TECHNICAL SERVICE BULLETIN (TSB) 20180813-01
Issued: August 13, 2018

Rebuilding Midland A-720 Series 2" Angle Valves Using Older Rebuild Kits with Supplemental Midland Kits K-720-100, K-721B-100, K-724-100

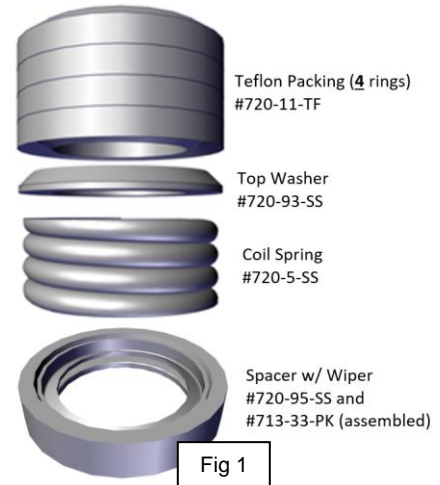
Scope: As of June 21, 2018 all Midland 2" Angle Valve Kits are supplied with the necessary components to rebuild the valve stem packing arrangement as directed by AAR Circular CPC-1335. The angle valve packing arrangement to make the Midland valve compliant is shown here in Figure 1.
